Dublin Landfill Siting

Tooman, Lusk, Co. Dublin.

Fingal Landfill Project Review of proposals

April 2005

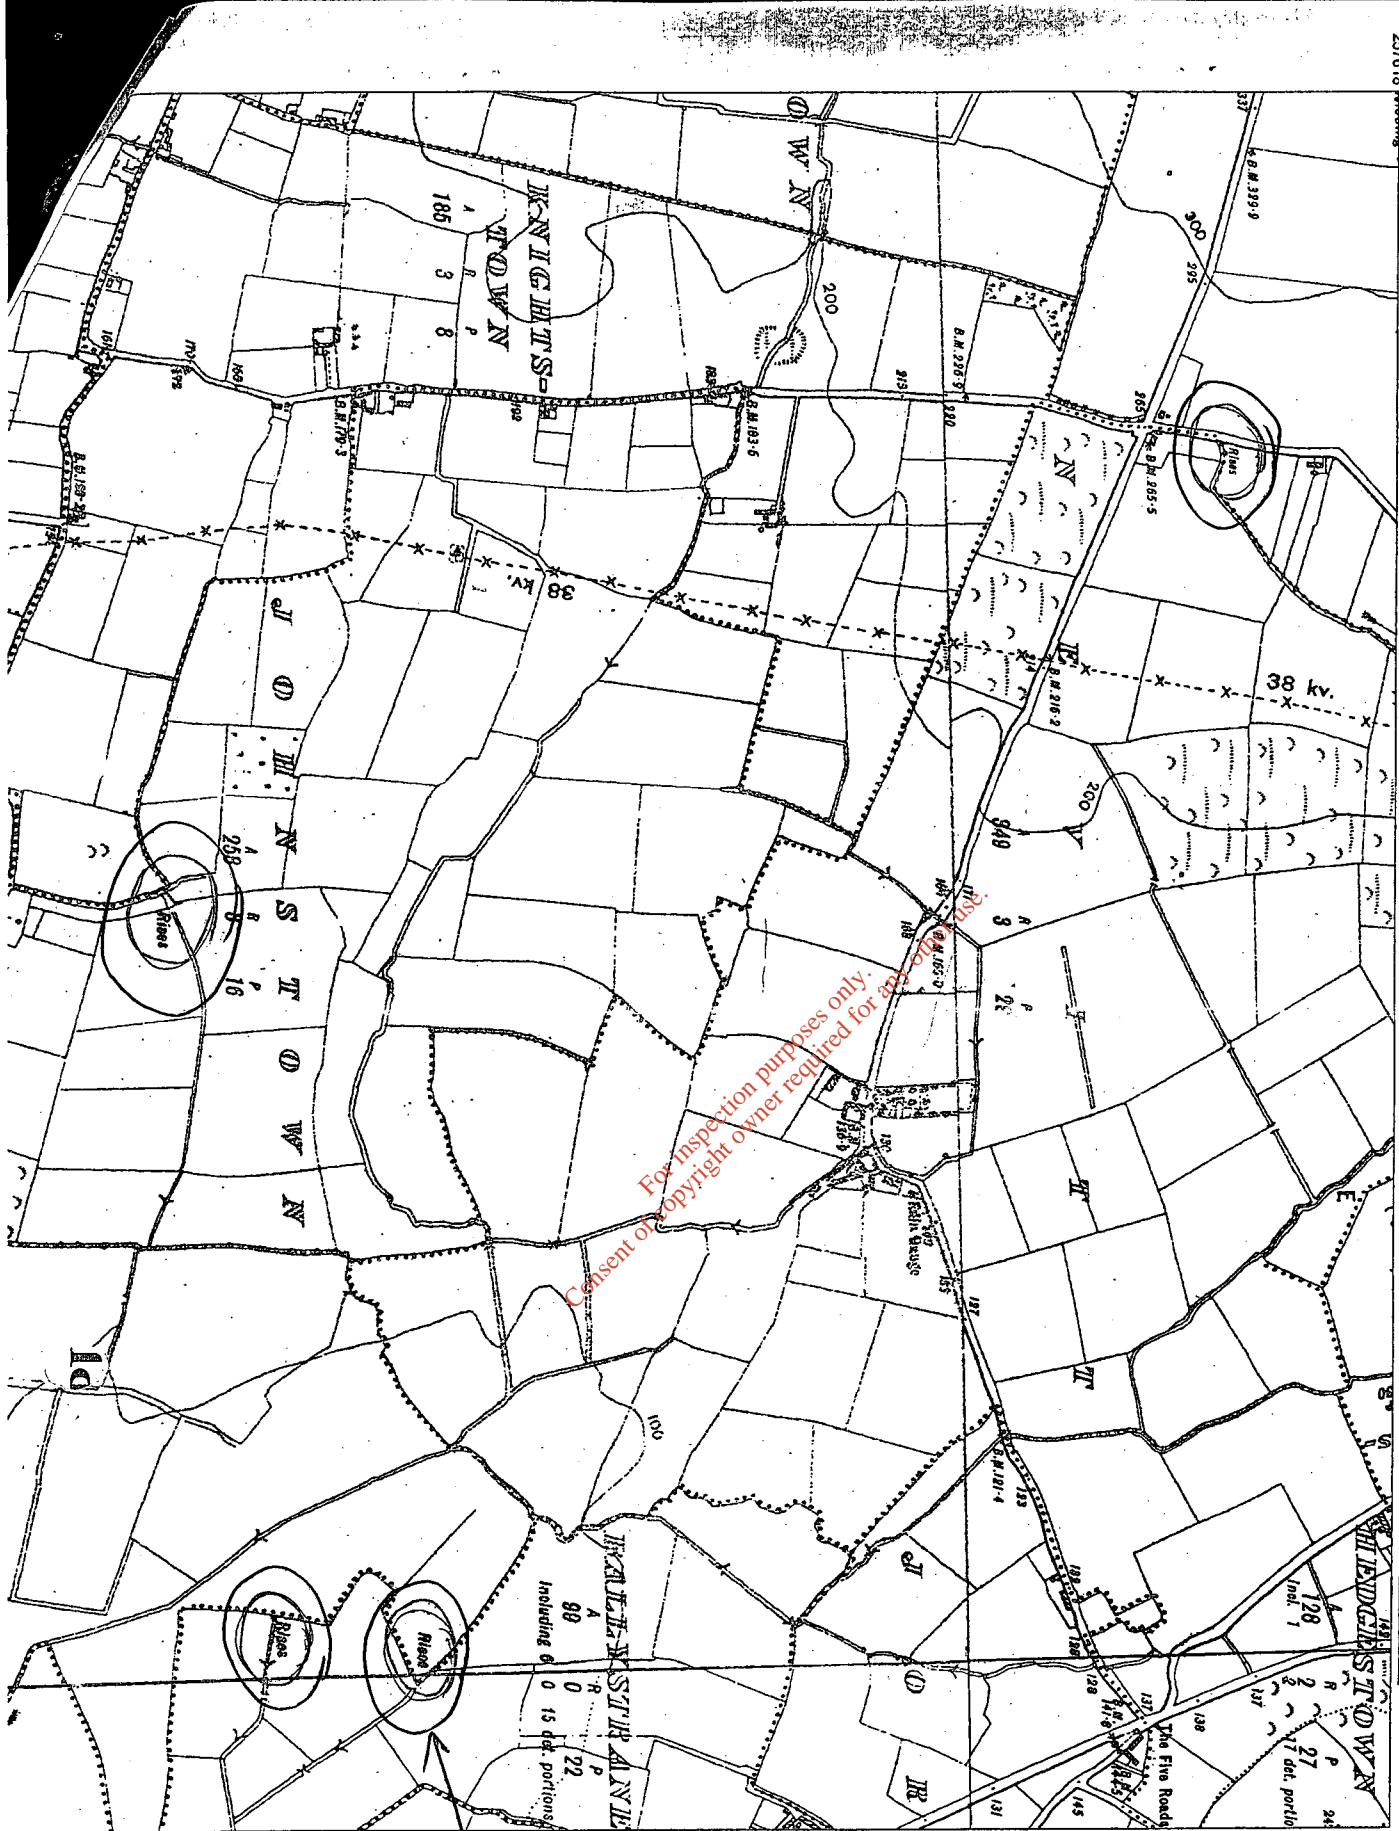
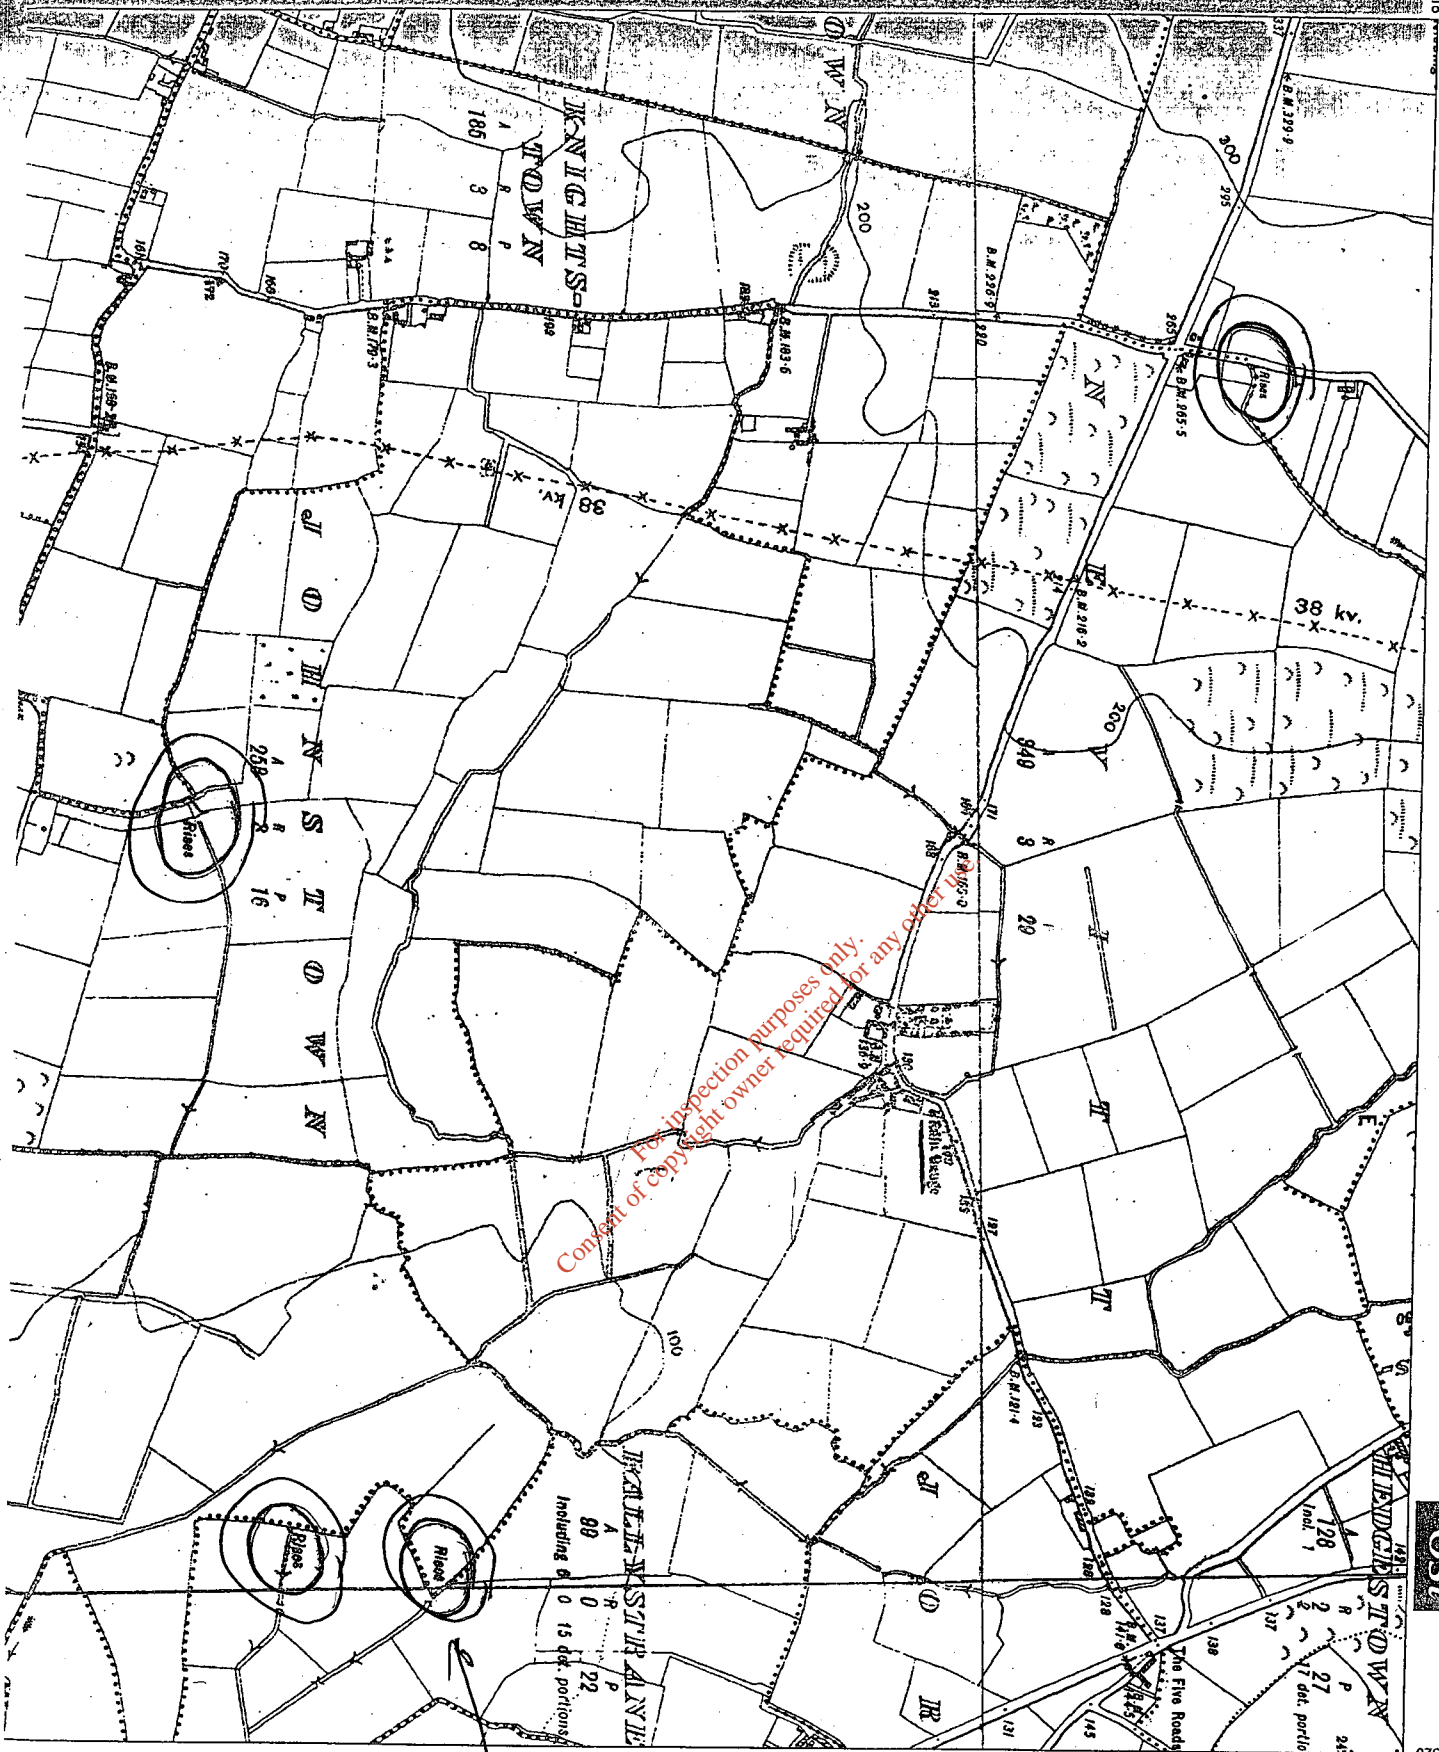
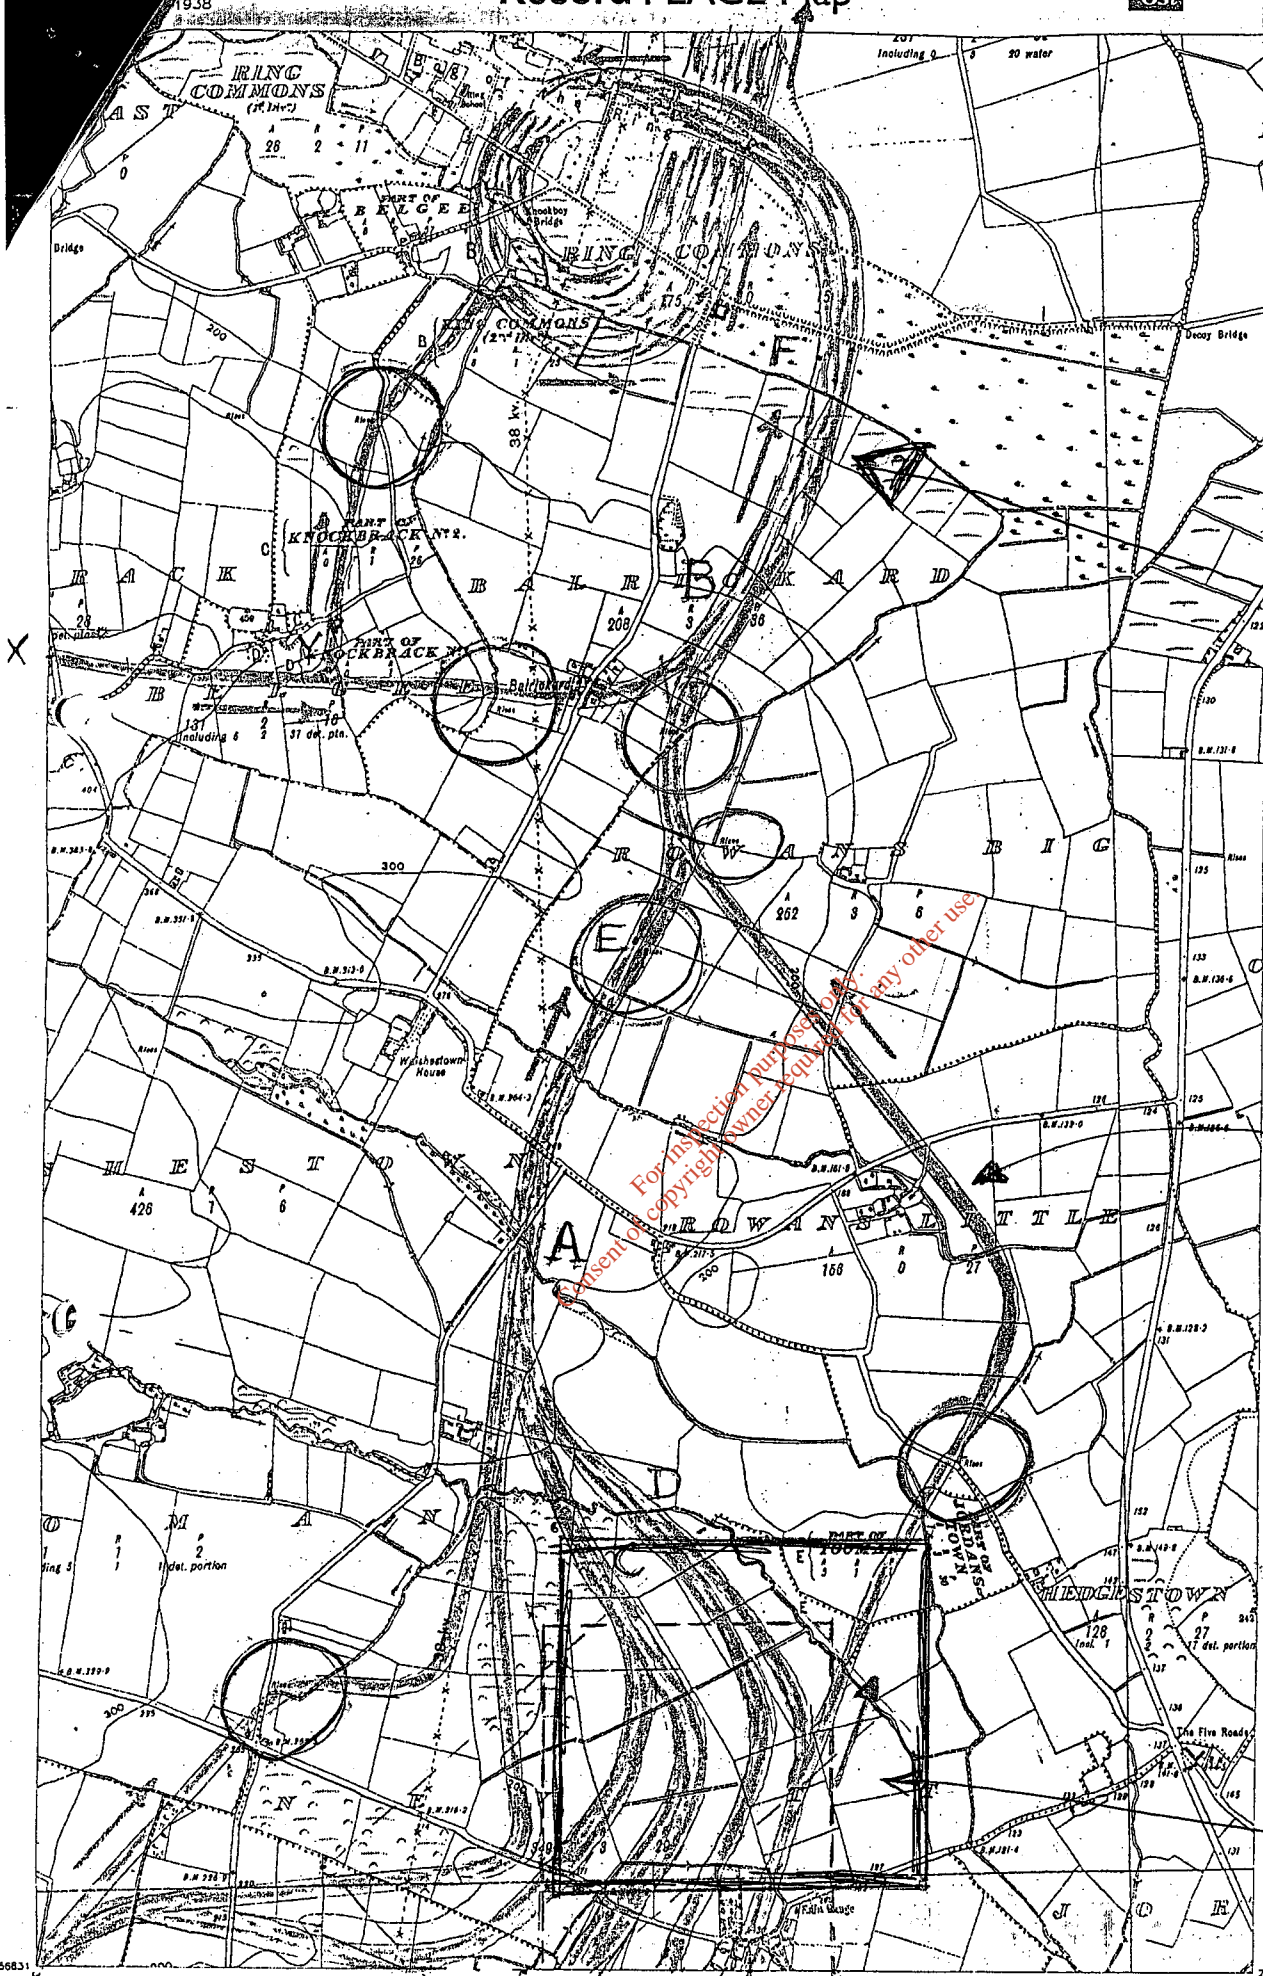
On attached map are marked in Red the lay-out of the aquifers in the Tooman to Bog of The Ring area. In the Tooman area several aquifers run more or less parallel to each other. These tend to converge into one main source, as the system moves northwards. Before reaching The Bog of The Ring, however, the channel becomes semi-circular and approaches The Bog of The Ring from an easterly direction. Having circled the "Bog" area, it appears to move in a north-easterly direction, to finally discharge into the Irish Sea, at a point north-east of Skerries.

The first information obtained from this map was the position of 6 No. "Rises". (These are shown Ringed Red on attached map). "Rises" are natural springs of water and indicate an aquifer in the strata beneath. They are, in fact, the overflow of aquifers. An investigation on site confirmed the existence of a complex system of aquifers in the Tooman - Nevitt area.

These aquifers are bearing their volume of water northwards and their contents eventually reach The Bog of The Ring. It is estimated that approximately 90% of the water delivered to The Bog of The Ring comes from the Tooman area. The remaining 10% appears to come from a westerly direction (X—Y on map).

Here the loose material of the aquifer (e.g. sand, gravel, etc.) alternates with and runs parallel to the firm strata separating the aquifers. An enormous weight is proposed to be placed on this area. Twice each year, as the water table rises and falls, very great stress will be placed on the land surface immediately beneath the fill. The ground over the aquifer will have to contend with the hydraulic pressure from beneath and opposing the load from the landfill. On the ground between the aquifers, where hydraulic pressure is absent stresses will be very low by comparison.

This condition will give rise to Differential Settlement. This may result in damage to the pipes, the membrane and the compacted impermeable layer. Consequently the system has the potential to fail, with disasterous results.

Should this opinion not be accepted by the Local Authority, it may be necessary to verify the findings on the ground. In this regard, I suggest that 2 No. deep-well borings be made (approx. 65 Metres) at the points A and B on attached map . 4 No. shallow wells (approx. 8 Metres) should be made at C, D, E, and F.. By pumping and by monitoring the water levels in the wells, it will be confirmed that the water at Tooman Landfill Site and the water at the pumphouse (at F on map)are, in fact, one and the same.

Figure 1: Proposed locations of boreholes to assess site superficial deposits

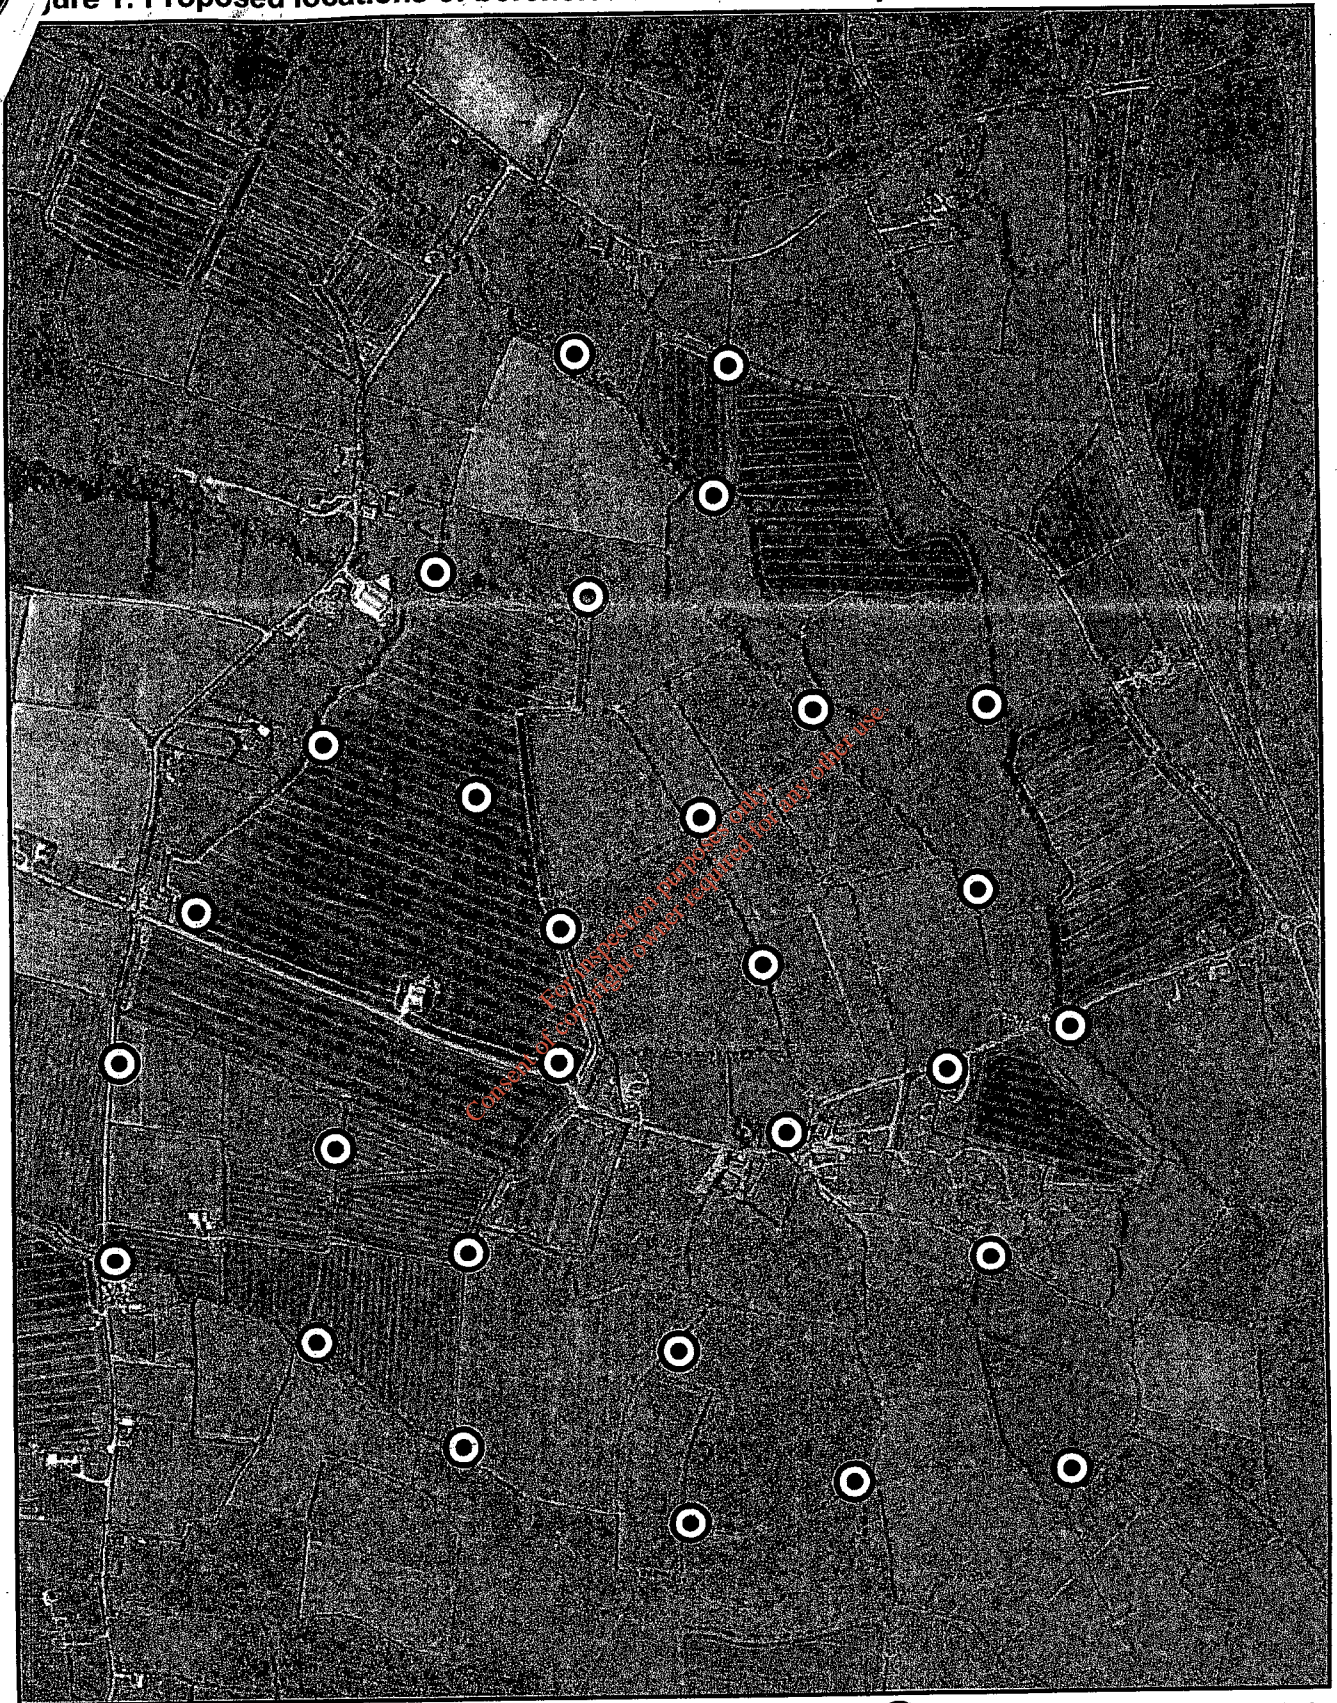
- (b) Detailed field investigations should be carried out to confirm characteristics of the superficial deposits across the whole site, in order to determine the site risk rating according to the GSI requirements, including: thickness, geological character and permeability, groundwater levels, and seasonal groundwater level fluctuation. Figure 1 shows the locations of proposed boreholes for this investigation. Permeability tests should be carried out in each borehole, and automatic water level monitors installed in 50% of them.
